RAMP REPORT REGION 2 ADA 2026

Lawerence St., & Ingraham Lane,
Rockland

CR 09032

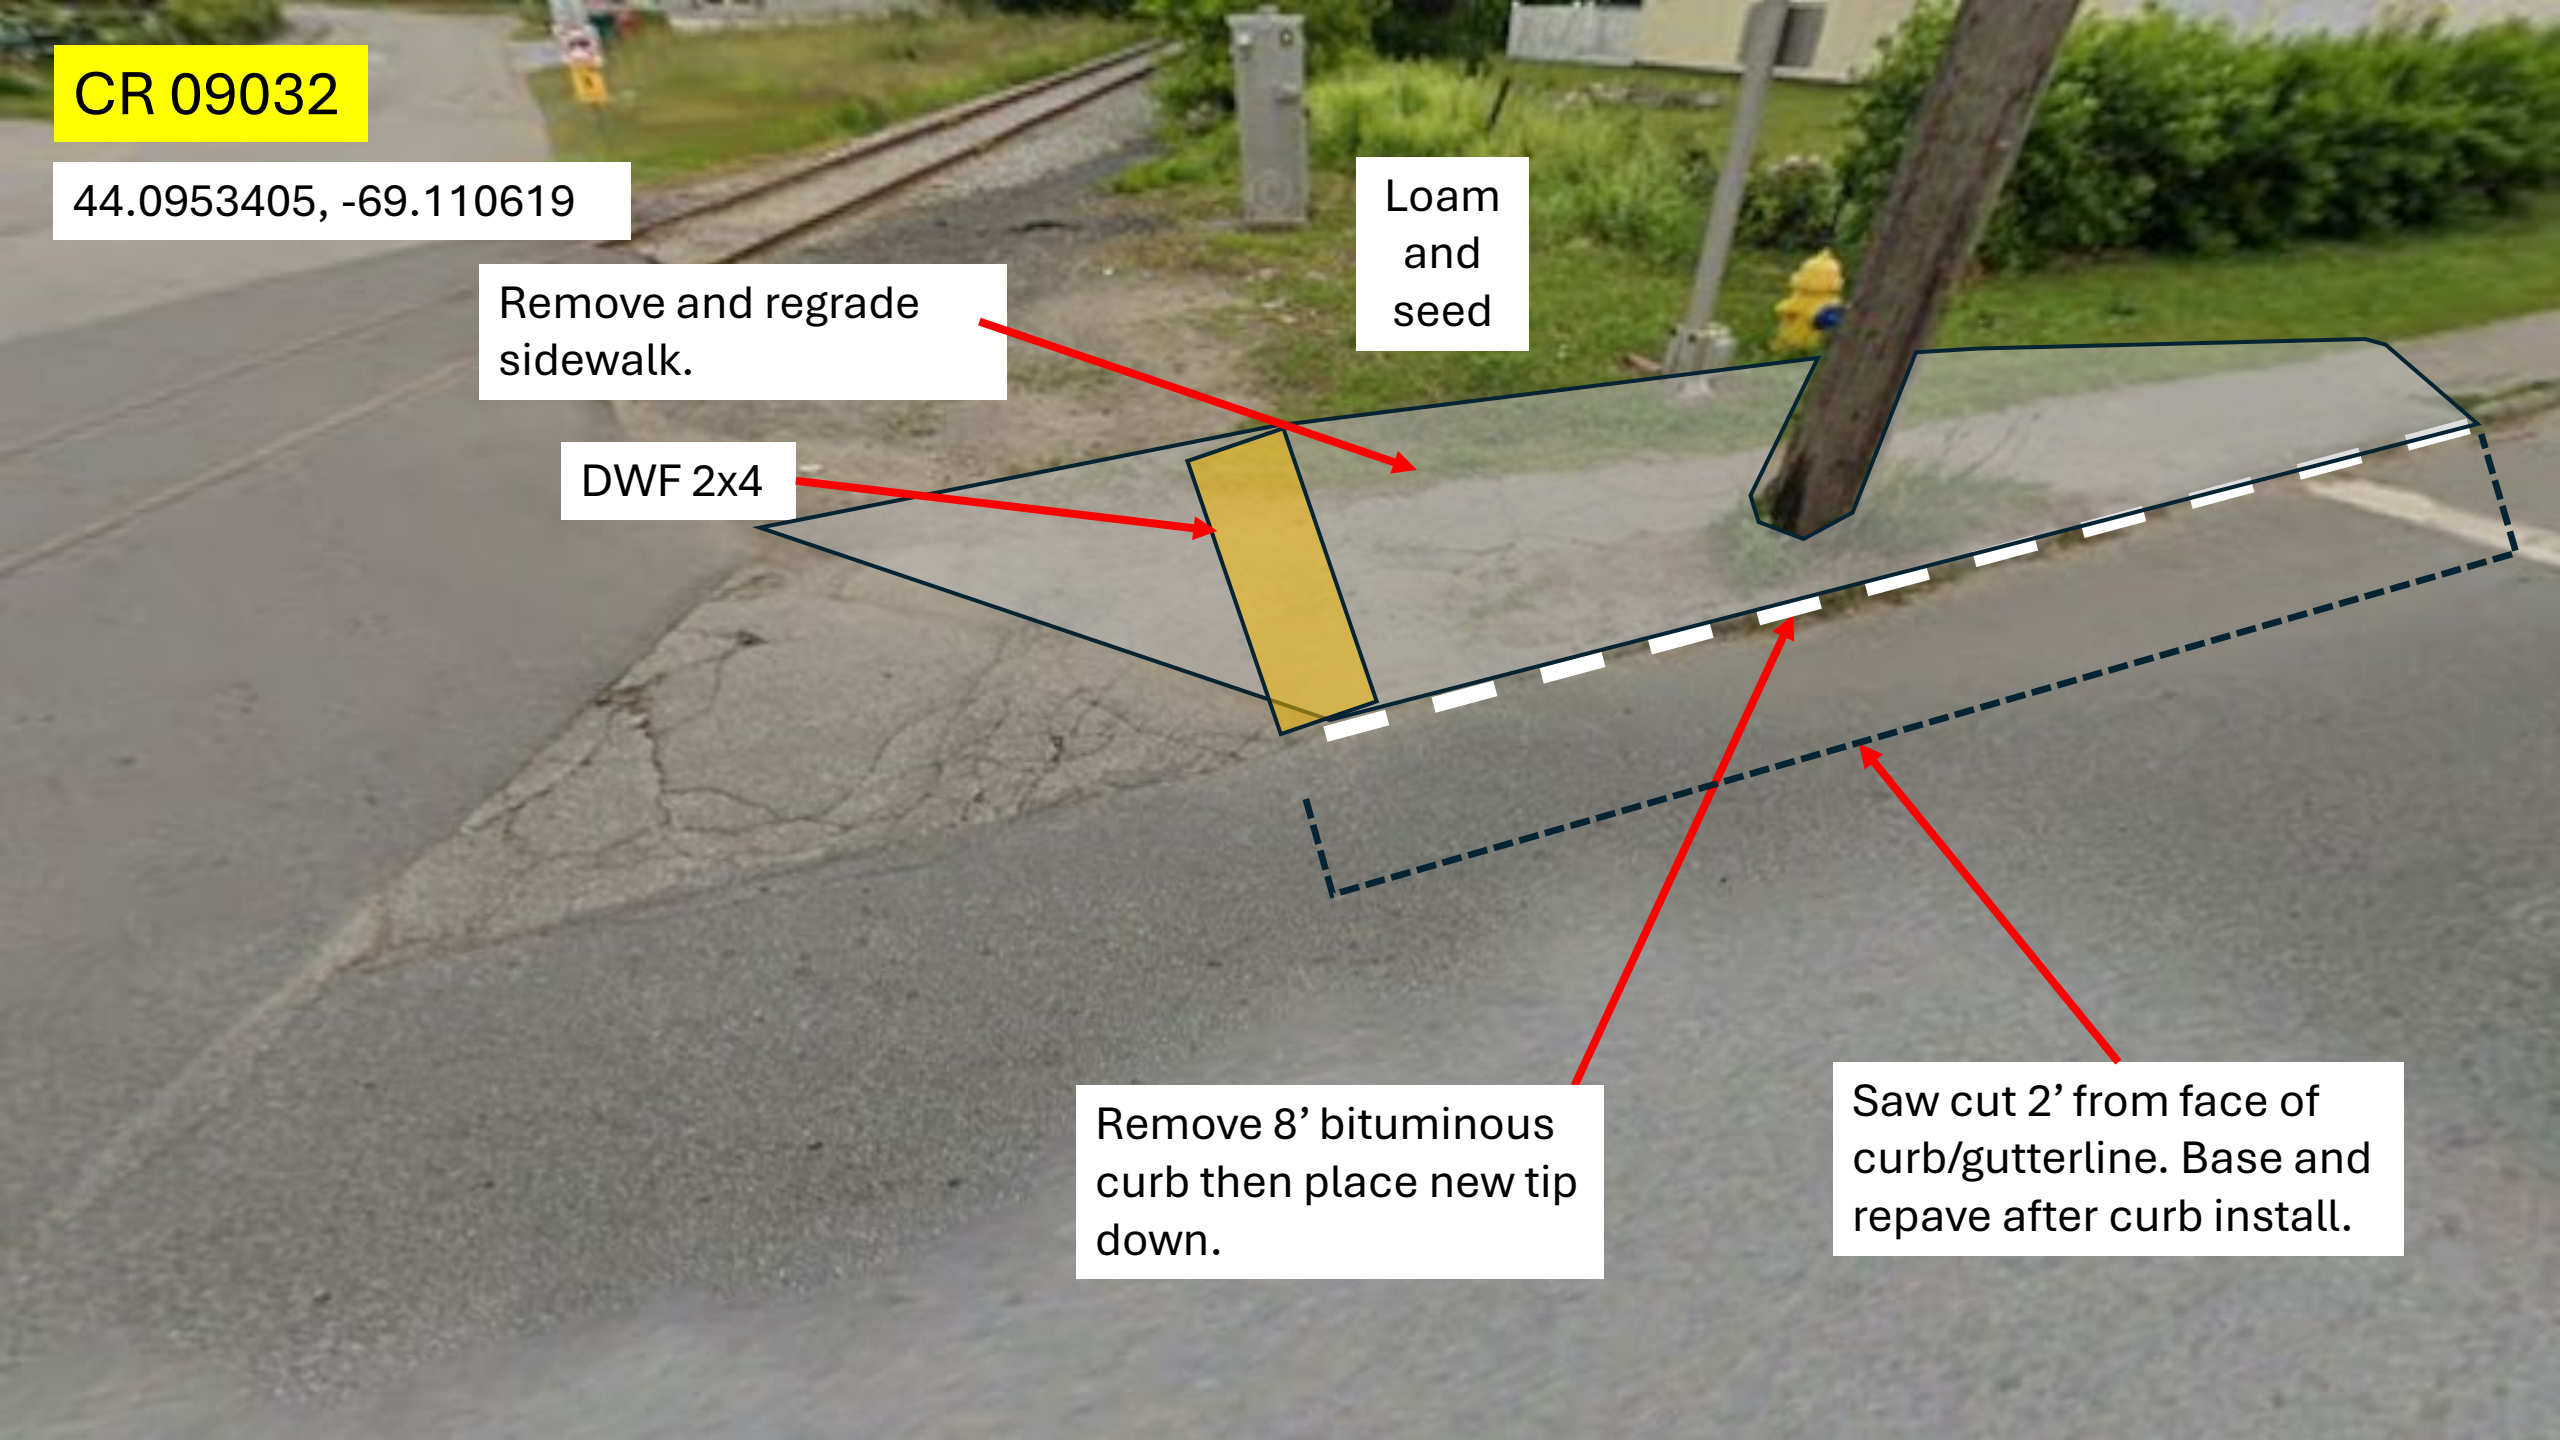
Remove and regrade
sidewalk.

Loam
and
seed

DWF 2x4

Remove 8' bituminous
curb then place new tip
down.

Saw cut 2' from face of
curb/gutterline. Base and
repave after curb install.

CR9035

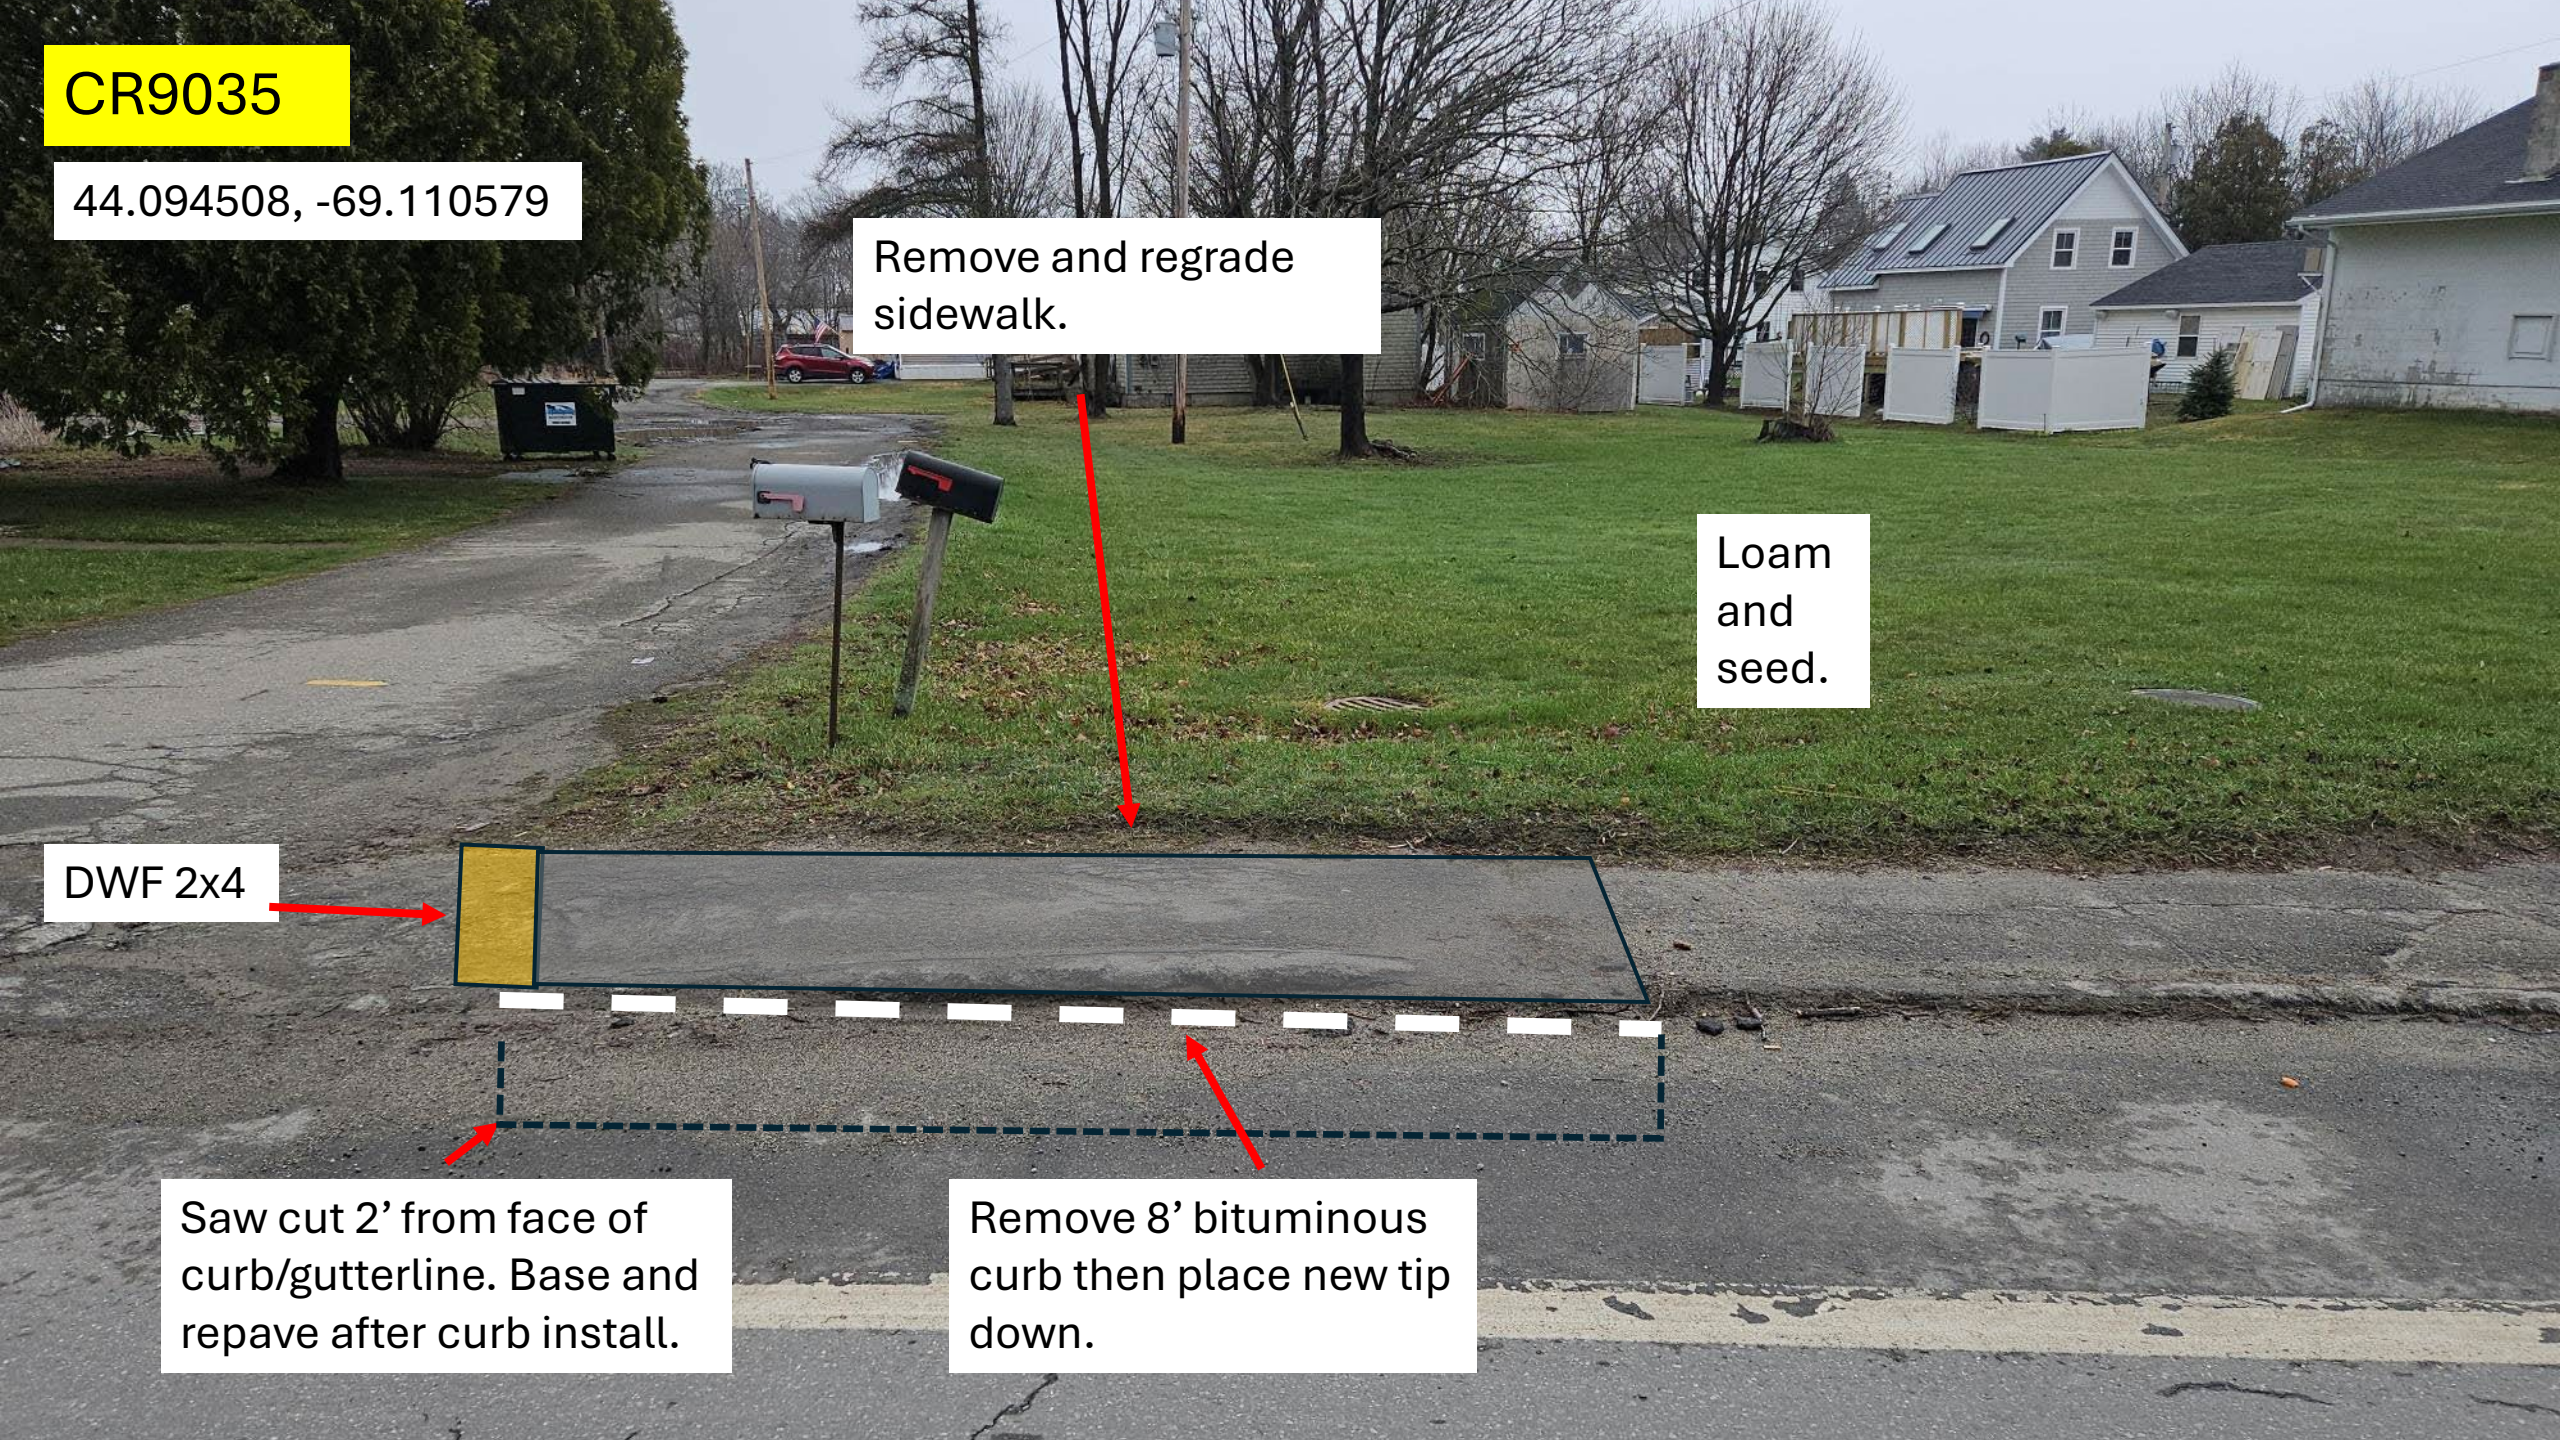
Remove and regrade
sidewalk.

Loam
and
seed.

DWF 2x4

Saw cut 2' from face of
curb/gutterline. Base and
repave after curb install.

Remove 8' bituminous
curb then place new tip
down.

CR09036

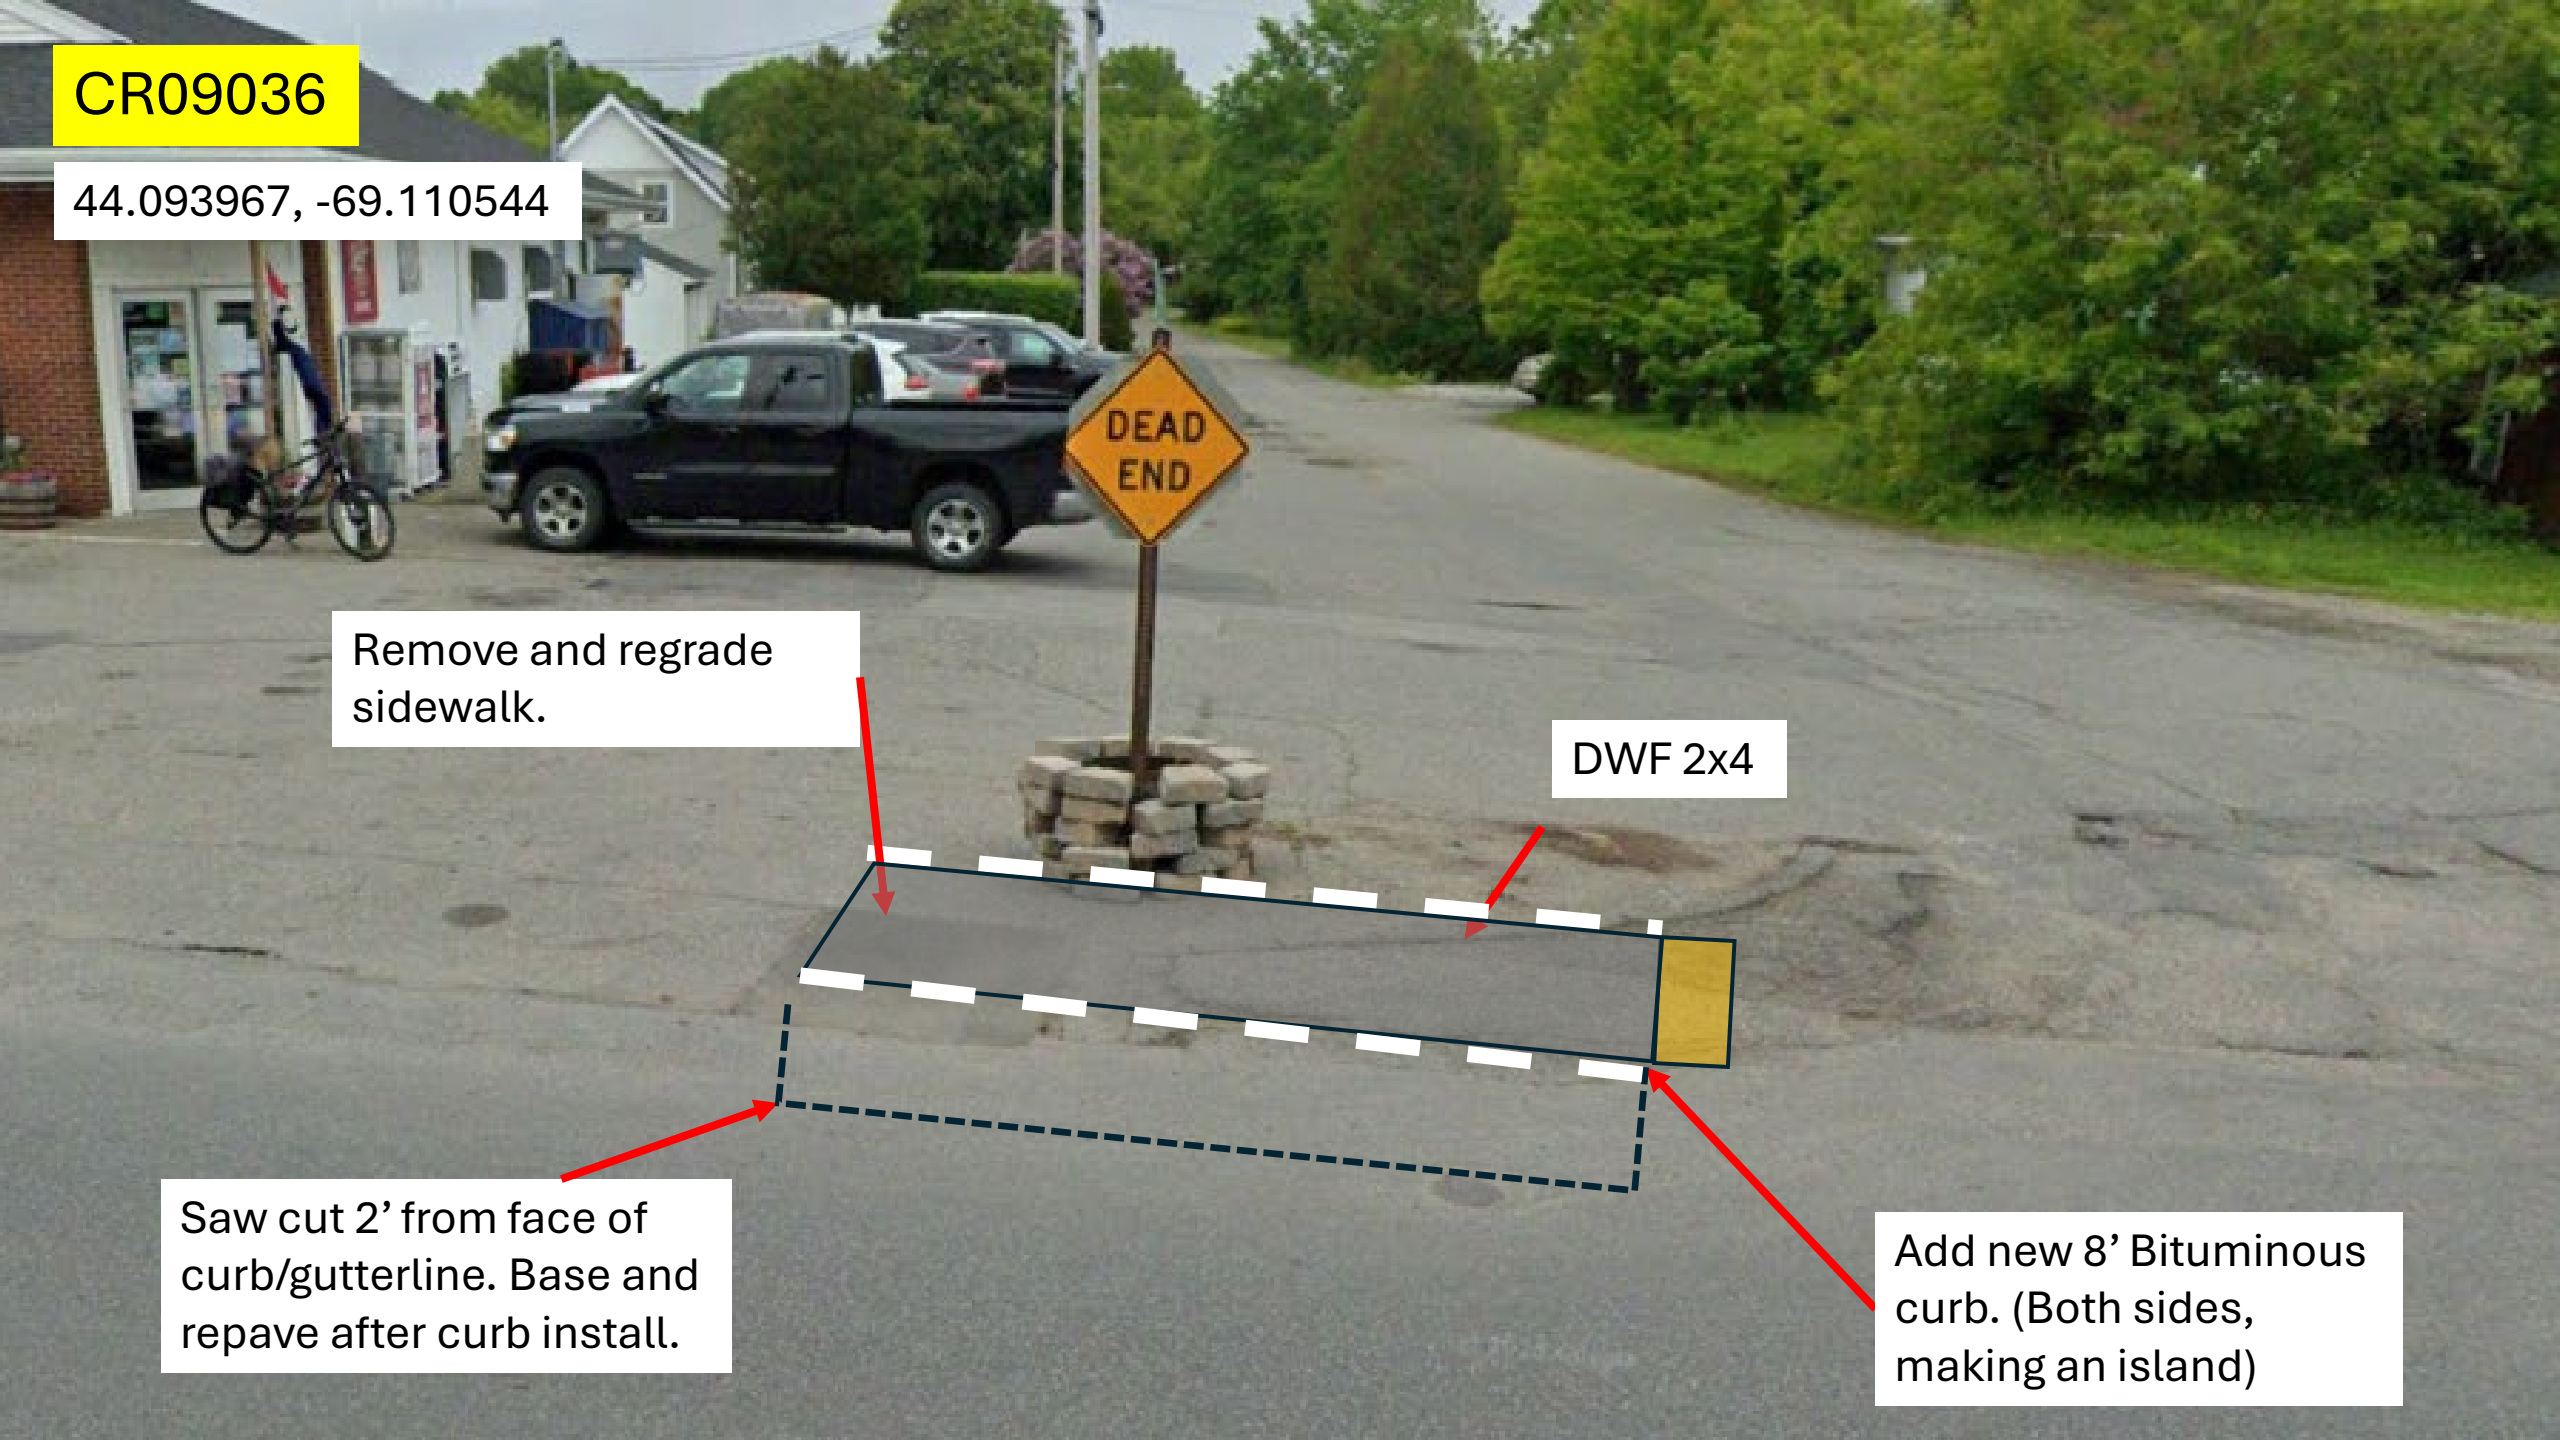
Remove and regrade
sidewalk.

DWF 2x4

Saw cut 2' from face of
curb/gutterline. Base and
repave after curb install.

Add new 8' Bituminous
curb. (Both sides,
making an island)
